SITE PLAN REVIEW AND APPEARANCE BOARD STAFF REPORT

Delray Beach Ocean Club

Meeting	File No.	Application Type
November 9, 2022	2021-194-SPF-SPM-SPR-CL3	Class III Site Plan Modification
Property Owner	Applicant	Agent
Delray Beach Club Inc.	GE Architecture Inc./Gary P. Eliopoulos	GE Architecture Inc./Gary P. Eliopoulos

Consideration of a Class III Site Plan Modification, Landscape Plan, and Architectural Elevations for Delray Beach Club, located at 2001 South Ocean Boulevard, associated with the construction of a one story covered parking garage (17,243 SF) with two rooftop tennis courts.

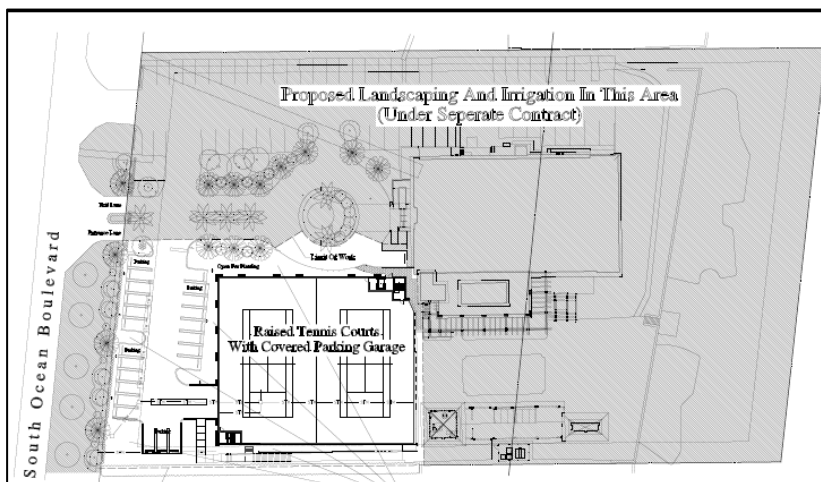
The landscaping for the Delray Beach Club is being completed with each of the approved phases. The current proposal is phase four while the other three phases are part of an approval for the front entrance and along the rear yard between the existing club house building and the dune vegetation that was approved by SPRAB in June 2022. (See plan to the right that indicates all the shaded area as Phase One - three).

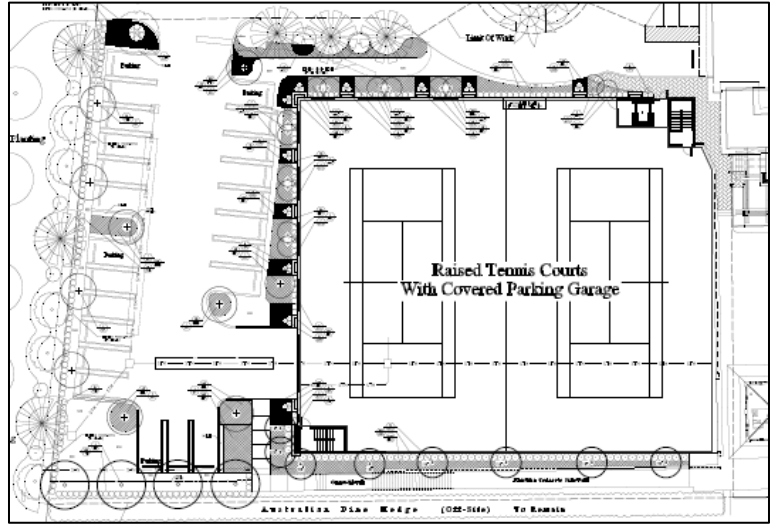
The tree mitigation is provided on TD-1, which indicates the relocation and removal of Palms and Trees. Phase Four mitigation is contingent on the completion of the first three phases. Pursuant to **LDR 4.6.19(C)(2)(c) Vegetation removal permits for development applications**, a condition assessment (See Appendix "A" for definitions) for all trees performed by a certified arborist that describes the condition percentage rating of the tree, makes note of hazardous trees and identifies trees that are a threat to endanger structures, pavement, and/or utilities. Those trees that are identified to be relocated will require a written assessment of transplant feasibility. The tree mitigation cannot be completed on phase four until the first three phases have been completed. Given the improvements required by the prior phases that are within the limitations of Phase Four, the arborist report for phase four will be provided at the time of building permit and is noted on the site and landscape plan. If the report determines that the existing trees require mitigation, then a site plan modification will be required to address the insufficiency and will need to provide the sufficient height, clear trunk, DBH, and condition rating.

1. Prior to building permit issuance, a landscape arborist report for Phase Four will be required to be submitted and reviewed for compliance.
